Re: Limitorque Corporation  
Part 21 Notification

Subject: SMB-000 and SMB-00 Torque Switches

SUBJECT: 10 CFR Part 21 Notification

**DOUBLE TORQUE SWITCH SMB-00/SMB-000**

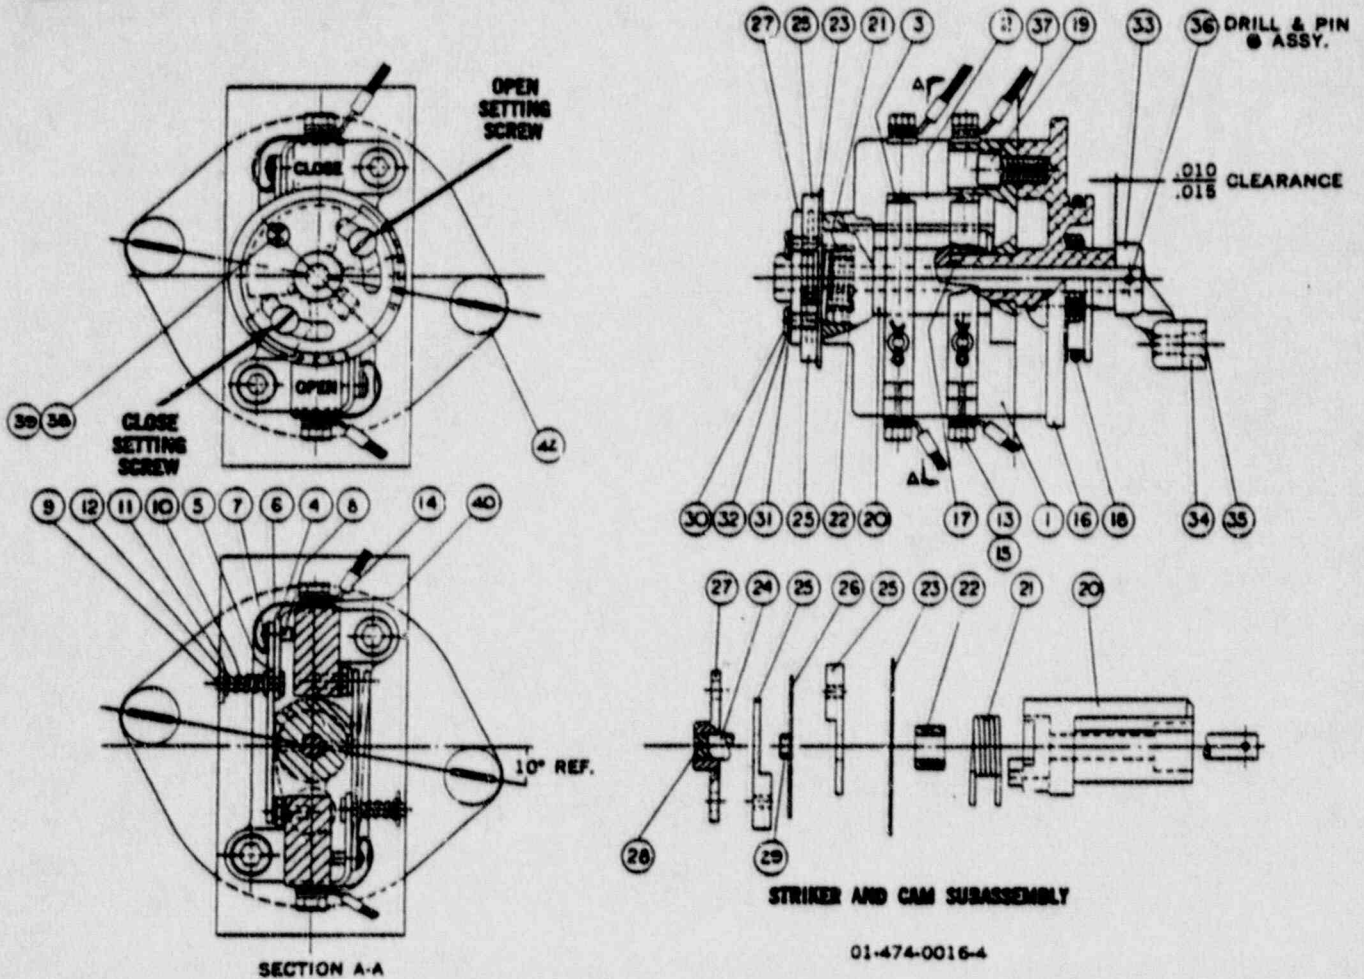
The component of concern is the SMB-000 and SMB-00 cam-type torque switch with fiber spacers under the contact bridge (see attachment #1).

A single SMB-000 torque switch failure occurred at two plants as a result of the stationary contact screws loosening on the side of the torque switch which had fiber spacers. The fiber spacers were installed on one side of the torque switch to provide equal spring pack compression in each direction to balance the torque switch.

Two types of failure modes have been reported. In one case only one screw came loose eliminating electrical continuity with the contact bridge resulting in a premature trip point on the torque switch. The second case occurred when both stationary contact screws loosened and the contact fingers were raised while continuity was maintained. This resulted in a condition where greater spring pack compression was required before the electrical contacts would open, in this case the electric motor went to locked rotor before the actuator could produce sufficient output torque to break the torque switch contacts. In both cases, the stationary contact screws that loosened were on the contacts which had the fiber spacers.

A similar torque switch failure had occurred in 1980 at the Susquehanna Plant. At that time, it was hypothesized that the cause of the loosening of the contact screws was a result of the fiber spacers taking a set and releasing pre-load from the contact screws, thus allowing the screws to loosen. At this time a Part 21 determination concluded that this was not a reportable incident as it was a single failure of a component which had a large population in use in the industry. In response to this concern Limitorque modified the torque switch design to replace the fiber spacers with additional metallic contact bridges to insure that no further difficulties would be encountered.

Limitorque recommends that those SMB-000 and SMB-00 actuators with the cam-type torque switch with fiber spacer be replaced. To date, we have received reports of three failures of this torque switch configuration which represents less than one tenth of one percent of the total population of these switches. Consequently, we are recommending that these switches be replaced during the next available maintenance period.

Limitorque modified the SMB-000 torque switch in 1980 and the SMB-00 torque switch in 1976, therefore all new torque switches manufactured after this period are not subject to this problem.
